MEMORANDUM

SUBJECT: FMBZA #19557A – Australian Embassy (1601 Massachusetts Avenue, N.W)
MODIFICATION OF CONSEQUENCE - SUBTITLE Y § 703

The application of the Government of the Commonwealth of Australia, pursuant to 11 DCMR Subtitle Y § 703, is a modification of consequence of the plans approved by BZA Order No. 19557 including refinement of components of the **architectural elements, increase in the height of one art piece in public space, removal of one proposed street tree in public space, and inclusion of signage** for the chancery building.

Location and Zoning Map

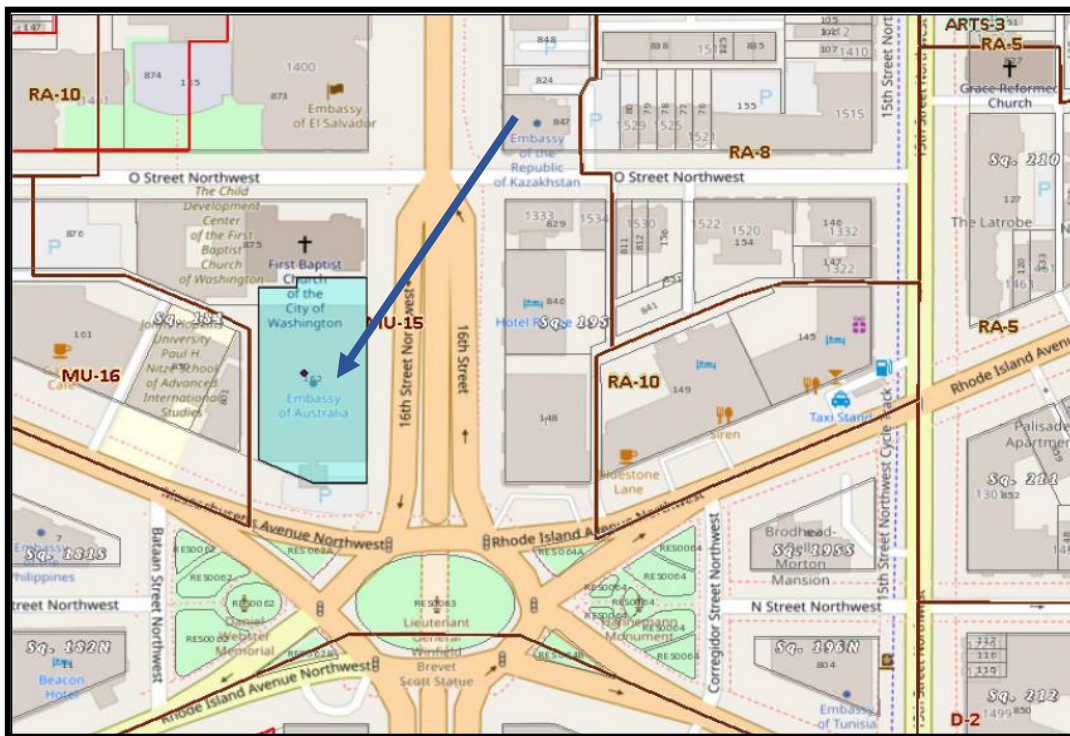
Address	1601 Massachusetts Avenue, NW
Applicant:	Commonwealth of Australia
Legal Description	Square 181, Lot 162
Ward / ANC	Ward 2; ANC 2B
Zone	MU-15: The Mixed-Use (MU) zones provide for mixed-use development that permit a broad range of commercial, institutional, and multiple dwelling residential development at varying densities. A chancery is a use permitted by special exception subject to FMBA review.
Historic District or Resource	The building is considered a non-contributing structure in the Massachusetts Avenue and 16 th Street Historic Districts, as it was built in 1969, which is outside of the district’s period of significance (1815-1959).
Lot Characteristics	The irregularly-shaped lot is located on the northwest intersection of 16 th Street, Massachusetts Avenue and Scott’s Circle
Existing Development	The existing chancery is a rectangular, seven-story, marble-clad concrete, glass and steel structure, with below grade parking for 90 vehicles. The pedestrian and vehicular entrances are from Massachusetts Avenue.
